DELEGATED DECISIONS BY CABINET MEMBER FOR TRANSPORT MANAGEMENT

OXFORD: A420 BOTLEY ROAD (RAIL STATION AREA) – PROPOSED HIGHWAY IMPROVEMENTS/CYCLING AND PEDESTRIAN INFRASTRUCTURE

Report by Corporate Director for Environment and Place

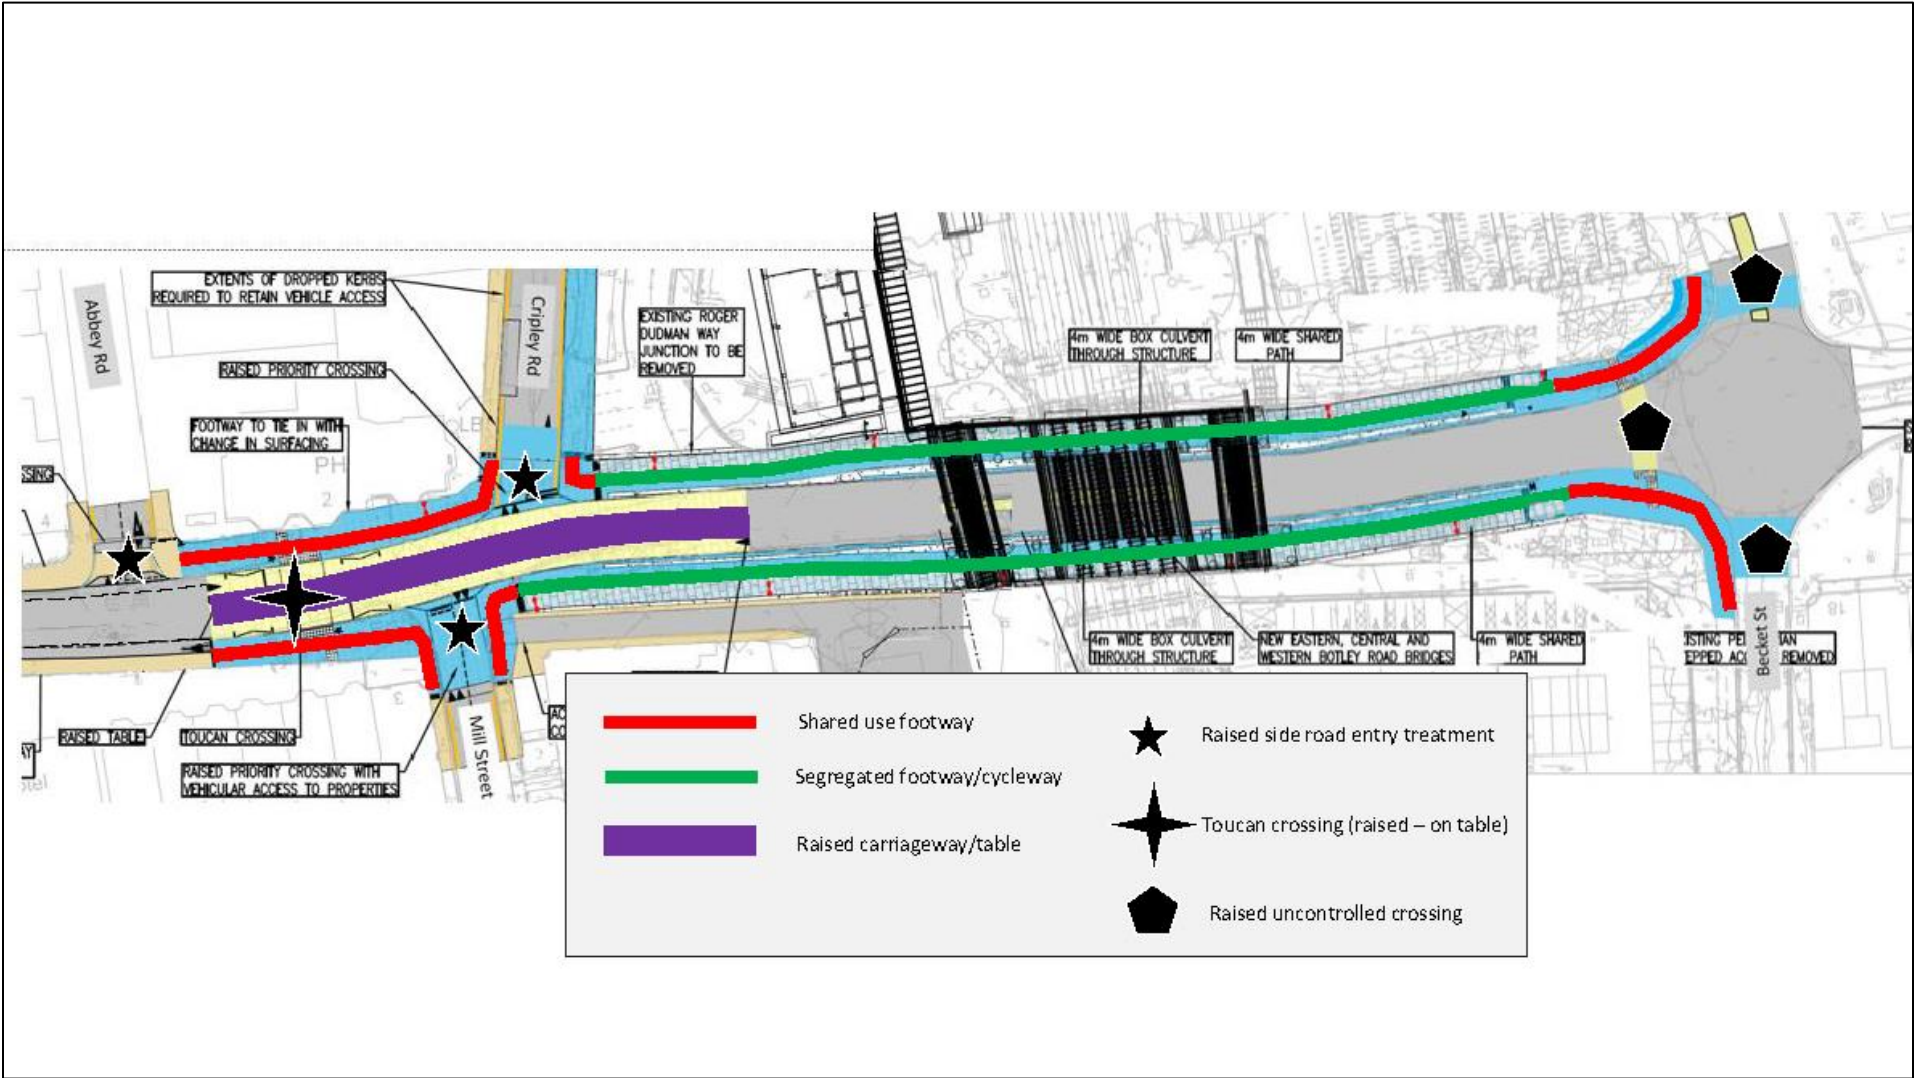
The plan on the website is not at all clear in many respects. It is very low resolution. It raises so many questions as to render the consultation unfair. I have looked on the website to see if the other information contained answers to my points, but I did not find those answers.

1. The panel that I would describe as the legend does not explain the meaning of the light blue, yellow and beige areas on the plan.
2. The new western entrance to the railway station is not shown.

4. The existing junction with Roger Dudman Way is to be removed. What is to be put there instead?
5. The caption on the plan at the entrance to Beckett Street is not complete and so one cannot read what it is saying.

6. At the far left (Western) end of the plan there are three black lines pointing to the star which represents the entry treatment for Abbey Road. Yet the captions showing what these lines are leading to were not visible on the plan.

7. As if to illustrate my point, my friend who lives in the area spotted '{Ex]isting Pe[lic]an [st]epped ac[cess] removed' somewhere on the plan. I could not see this.

41. A number of respondents didn't think the plan was clear enough or contained enough detail to allow a proper understanding of what was being proposed. The aim of the plan (in Annex 1) was to show the location and extent of the key elements of the proposed Network Rail design that were the subject of this statutory consultation; not the full detail of the proposals. This will be completed following this Cabinet Member Decision meeting taking into account the feedback submitted. Officers believe that the description of the proposals on the Let's Talk Oxfordshire consultation page and the press notice were more than adequate to allow proper consultation on the key features.
